SYDNEY OLYMPIC PARK

Finalisation Report

Review of Master Plan 2030 and *State Environmental Planning Policy (State Significant Precincts)*

November 2017

Central Precinct - Site 53

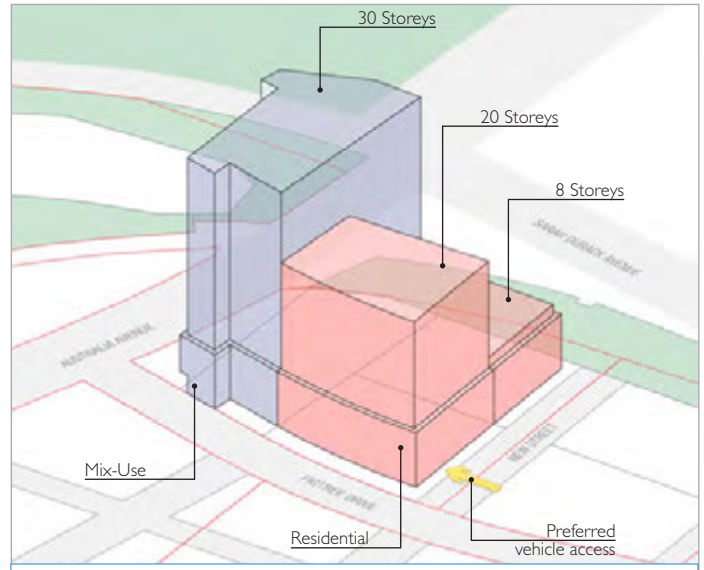
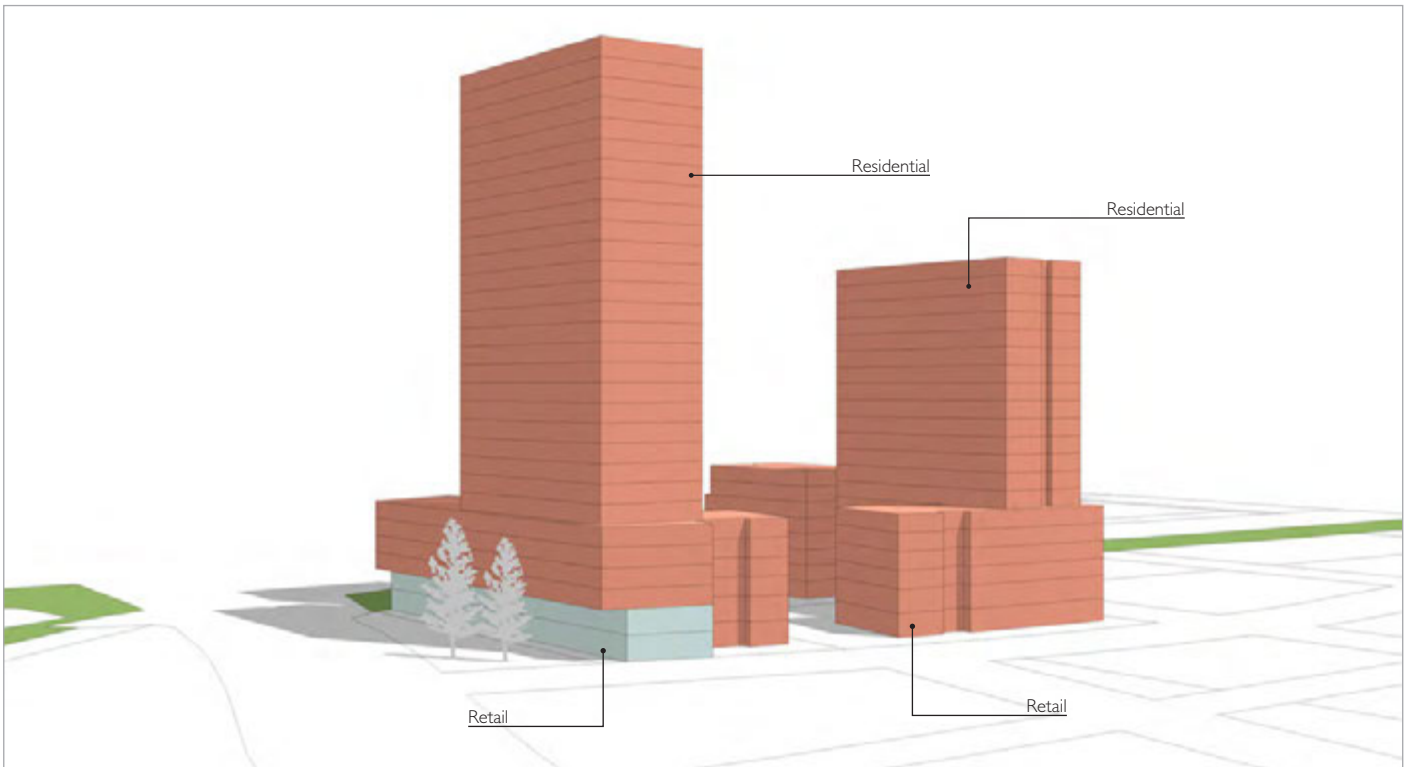
Request: Requirement for 3 hours of direct sunlight in at least 75% of dwellings is excessive and unachievable within the future dense urban environment of Sydney Olympic Park.

Response: The Apartment Design Guide should be used as the overarching control to ensure residential amenity is achieved within Sydney Olympic Park.

Recommendation 1: It is recommended that Site 53 is removed from Figure 4.6 – Design Competition Sites Plan in Section 4.6.10 of the 2016 Review to acknowledge the competition of the Site 53 Design Excellence Competition and the appointment of the winning Architect, BVN.

Recommendation 2: It is recommended that the draft Floor Space Ratio Map contained within the proposed amendment to SEPP State Significant Precincts 2005 and Figure 5.6 Central Precinct Site Floor Space Ratios Plan of the 2016 Review are amended to provide a floor space ratio of 5:1 for Site 53.
